Re-alignment of Gas Main Consent SSD_5093 (Mod 1)

Response to Submissions

September 2015

“Plan of proposed new route of gas main to accompany an application by UGNSW to amend consent SSD_5093” (Ref: Drawing No. 13656B C-0-9-20 Rev. 4) prepared by Robert Bird Group

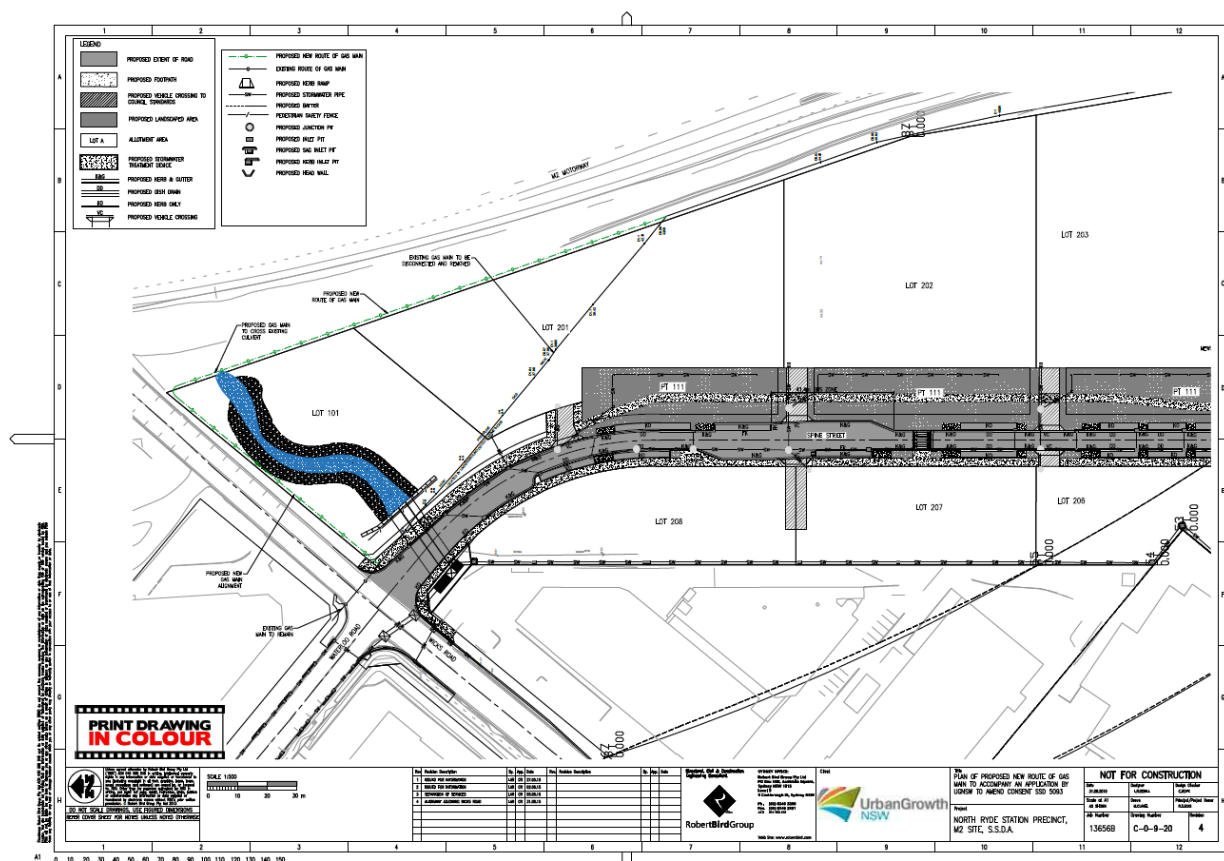
An amendment to the proposed alignment of the gas main is proposed in response to issues raised by Ausgrid related to the potential impact of the proposed gas main on existing 132,000v cables in the Wicks Road reserve.

ISSUE	RESPONSE
John McCain and Diane Michel	
<ul style="list-style-type: none"> Seeking clarification on the precise location and alignment of the proposed gas main in relation to the culvert in the M2 Corridor. 	The location of the proposed gas main is shown on the Plan at Appendix A . The gas main will be located within a 1.2 metre deep trench approximately at the centre of a 3 metre width corridor offset from the M2 Motorway Corridor Lands boundary.
<ul style="list-style-type: none"> Confirmation sought on the on-going management of the corridor. 	The M2 Motorway Corridor Lands is managed by the motorway operator, under the terms of a lease from the RMS. UGNSW will be responsible for the rehabilitation of the gas main corridor, in accordance with the recommendations of the Flora and Fauna Assessment prepared by ELA, consistent with the condition of consent invited in this modification application. Responsibility for on-going management of the M2 Corridor Lands rests with the motorway operator.

C23. A 5m wide path is to be cleared of trees along northern boundary of the Site within the Northern Bushland Reserve adjacent Wicks Road and in the M2 Motorway Corridor Lands generally in the location shown on the Plan of proposed new route of gas main to accompany an application by UGNSW to amend consent SSD_5093 (Ref: Drawing No. 13656B C-0-9-20 Rev. 4) and prepared by Robert Bird Group.

The response to the submissions and provision of additional information has resulted in an amendment to the proposed development, as shown in **Figure 1**. The new alignment of the gas main proposes to retain the approved alignment within the Lachlan's Line site along the Wicks Road frontage.
